Javelin/Spear/Merlin

Command 3

Range Modifications

Release date: December 1st 2001

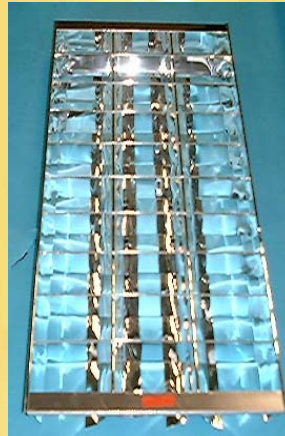
As from the 1st December the standard method of fixing Command 3 system into all Javelin, Spear and Merlin Cat2 louvred luminaires will become as shown below.

A Command 3 Cube is fitted to a standard louvre in all cases. A modified louvre (1 wedge subtracted) or machined in-fill section with extended body is not now required.

The Command 3 Cube (MS1200DI/S) is fitted to the louvre in-house, using punched Zintec bracket 25671-1-BK01 and 2off No4x3mm self-tapping screws - as per illustration.
